Conquip Boat Skip (CA122-03000) Recall

Safety Alert

Conquip Boat Skip (CA122-03000)

Date: 16/01/2019

Diagram showing correct free movement of retaining washer

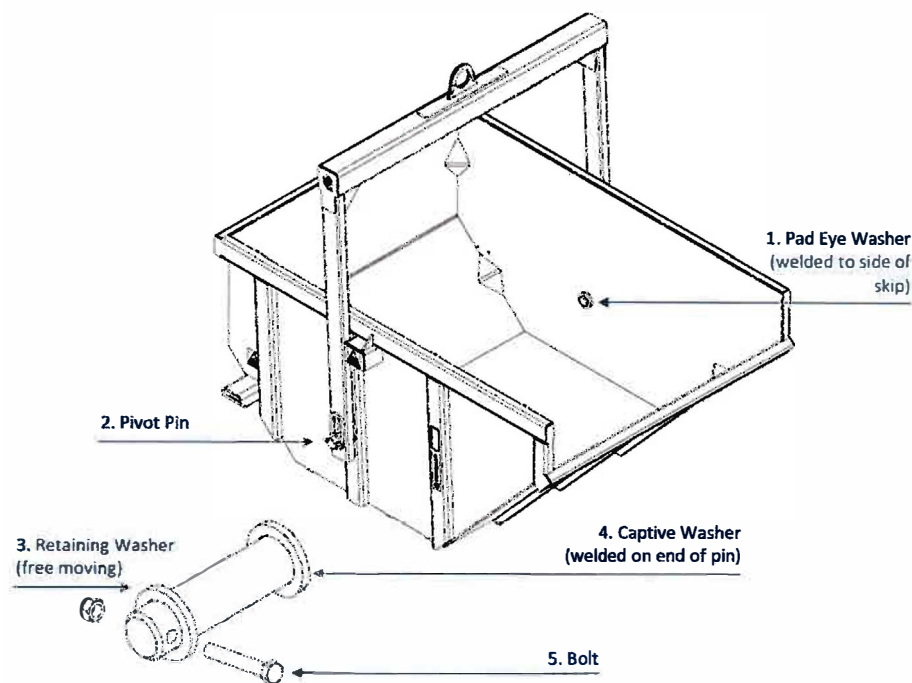
If the retaining washer (Item 3) on the end of the pivot pin (Item 2) is welded to the inside of the skip, therefore disabling free movement of the pin, these items should be quarantined.

The correct assembly should show the captive washer (Item 4) welded to the end of the pivot pin (Item 2) allowing free movement of the pin against the pad eye washer (Item 1) that is fully welded to the inside of the skip.

FIG 1

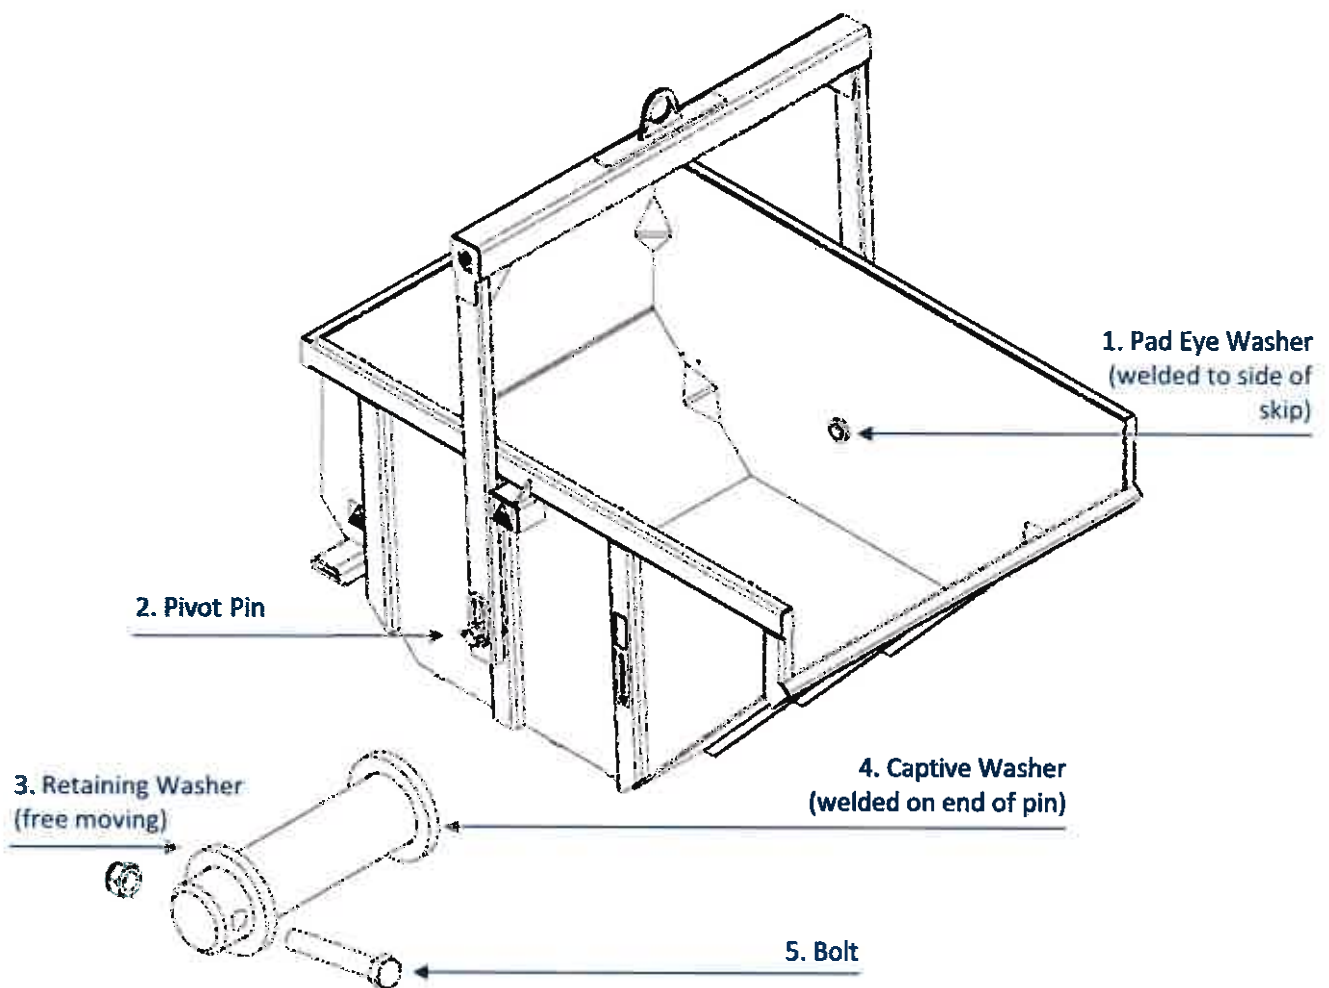
If the retaining washer (Item 3, FIG 1) on the end of the pivot pin (Item 2, FIG 1) is welded to the inside of the skip, therefore disabling free movement of the pin, these items should be quarantined. They should be returned to Conquip Engineering Group for remedial work or quarantined on site until one of our field service engineers can visit to carry out the necessary repairs.

The correct assembly should show the captive washer (Item 4, FIG 1) welded to the end of the pivot pin (Item 2, FIG 1) allowing free movement of the pin against the pad eye washer (Item 1, FIG 1) that is fully welded to the inside of the skip.
